# SERVICE BULLETIN

<b>SERVICE BULLETIN</b>		No.: ESB-99E11-504	
		Date: 1999-07-15	<Model> <M/Y>
<b>Subject:</b> CORRECTION IN CYLINDER HEAD BOLTS INSTALLING PROCEDURE		(EC) SPACE STAR (DG0A)	99-10
<b>Group:</b> ENGINE			
<b>INFORMATION</b>		 O. Kai - E.V.P. & G.M. After Sales Service Dept.	
<b>1. Description:</b>			
This service bulletin informs you of the Correction in cylinder head bolts installing procedure.			
<b>2. Applicable Manuals:</b>			
<b>Manual</b>	<b>Pub. No.</b>	<b>Language</b>	<b>Page(s)</b>
'99 SPACE STAR Workshop Manual Chassis	CMXE99E1	(English)	11A-28
	CMXS99E1	(Spanish)	
	CMXF99E1	(French)	
	CMXG99E1	(German)	
	CMXD99E1	(Dutch)	
	CMXW99E1	(Swedish)	
	CMXI99E1	(Italian)	
<b>3. Details:</b>			
Refer to the attached sheet.

**<Correct>**

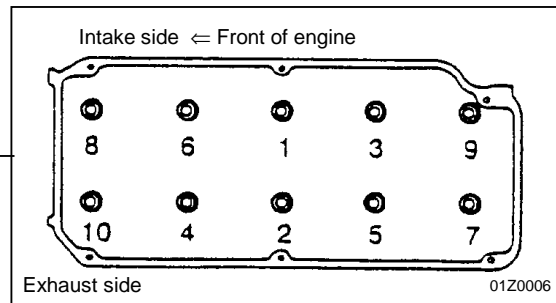
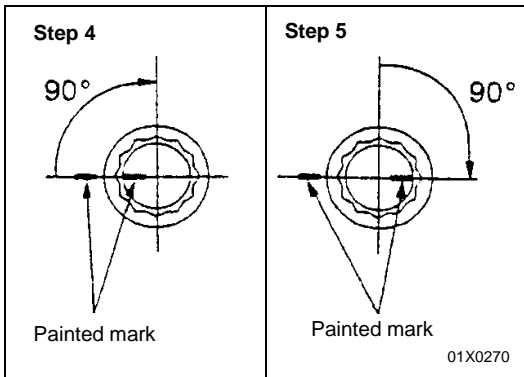
**Caution**

- (1) Always make a tightening angle just 90°. If it is less than 90°, the head bolt will be loosened.
- (2) If it is more than 90°, remove the head bolt and repeat the procedure from step 1.
